City of Dublin Zoning Board
Request for Variance
November 4, 2020

VARIANCE SUBMISSION

**DUNCAN RESIDENCE
8831 LOCHERBIE COURT
DUBLIN, OH 43017**

VARIANCE SUBMISSION

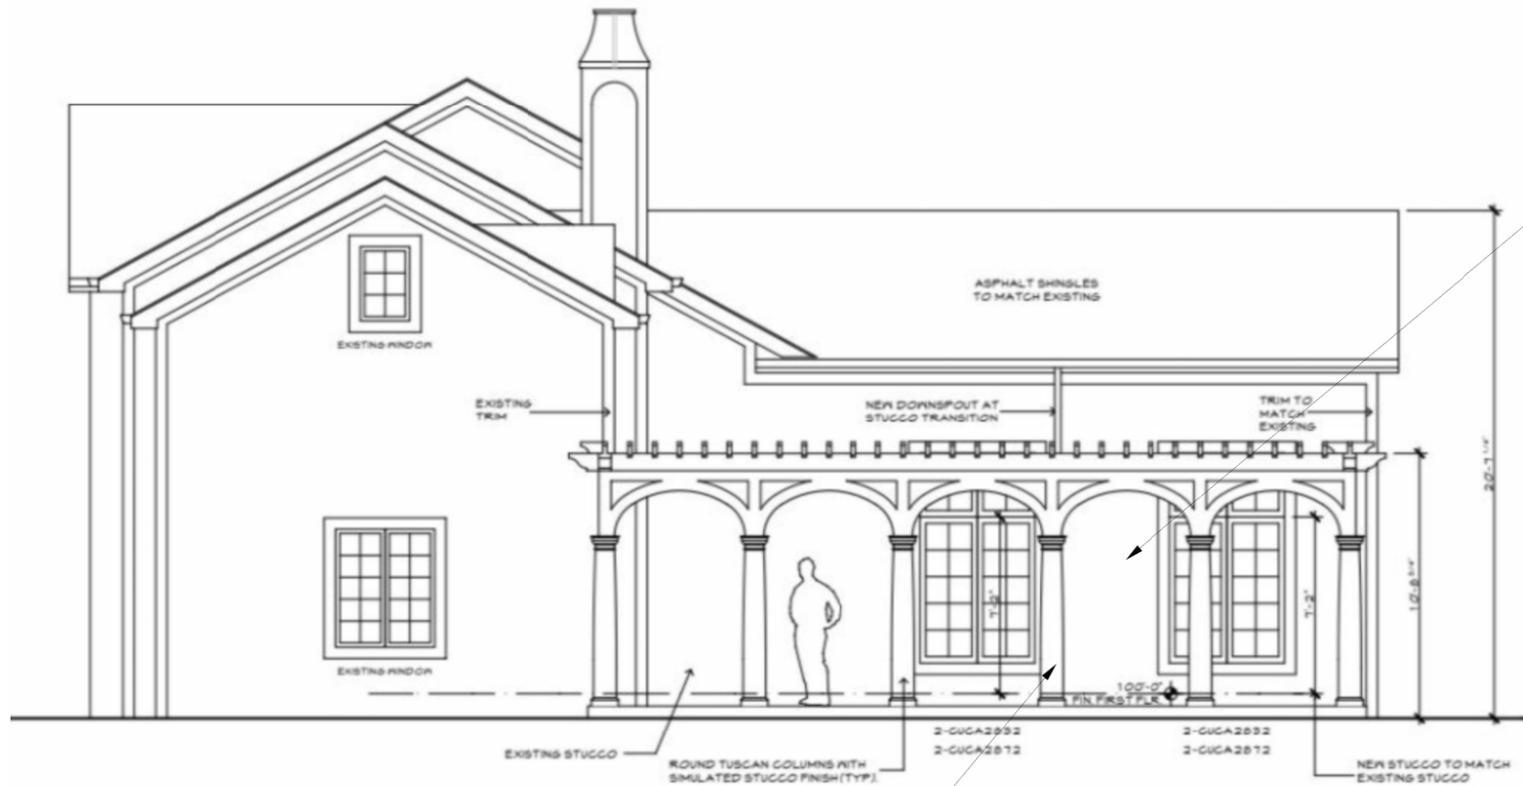
1) Variance to Zoning Code Section 153.074(C)(3) which is the minimum 10-foot separation between the swimming pool and the principal structure. Currently, it seems the proposed pool is just under 5 feet from the principal structure.

2) Variance to Zoning Code Section 153.074(C)(4) which is the required pool barrier that surrounds the proposed pool. It is our understanding that you are requesting to not have the pool barrier. This is not an item that is typically considered for a variance, as the measure is in place for safety reasons. This will take more deliberation on our end with the Building Standards department to determine if this is a possible variance request or not. Regardless if it is possible or not, our Staff would recommend a pool barrier per Code requirements.

VARIANCE SUBMISSION - SWIM SPA VS. POOL

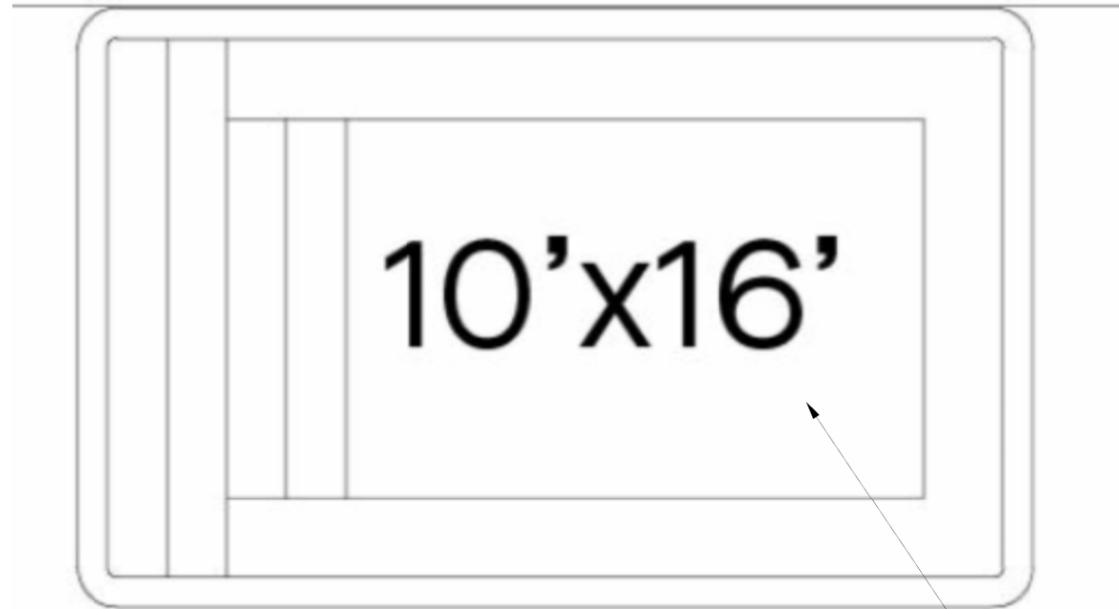
Hot tubs are permitted accessory structures, and may be either below or above grade, provided that they do not exceed 100 square feet in total water surface area, or 4.5 feet in depth or height as measured from finished grade.

10' X 16' IS THE DESIGNATION PROVIDED FOR THIS FIBERGLASS UNIT. THE ACTUAL INSIDE DIMENSION (WATER SURFACE AREA) IS 9' X 15' BECAUSE THE FIBERGLASS 'LIP' ON ALL SIDES IS APPROXIMATELY 6".

ALTHOUGH 9' X 15' = 135 SF OF WATER SURFACE AREA, MUCH OF THIS AREA IS TAKEN UP BY STEPS AND SEATING ALONG THE PERIMETER.

FOR EXAMPLE: FOLLOWING DUBLIN'S CODE OF 100 SF AT 4.5' DEEP, THIS WOULD EQUAL APPROXIMATELY 450 CUBIC FEET, WHICH IS 3,366.23 GALLONS OF WATER.

THIS PROPOSED SWIM SPA IS ONLY 2,500 GALLONS OF WATER DUE TO THE STEPS AND SEATING LEDGE TAKING UP MUCH OF THE WATER SPACE. (THIS IS 866.23 GALLONS LESS THAN WHAT IS CONSIDERED A HOT TUB.)

HOT TUBS DO NOT HAVE A MINIMUM DISTANCE FROM A PRIMARY STRUCTURE.

WE WOULD LIKE TO PROPOSE THAT THIS BE CONSIDERED A SWIM SPA IN LIEU OF A SWIMMING POOL, AND WOULD THEN PRESUME THAT WE COULD PLACE THIS SPA ANY DISTANCE FROM THE PRIMARY STRUCTURE.
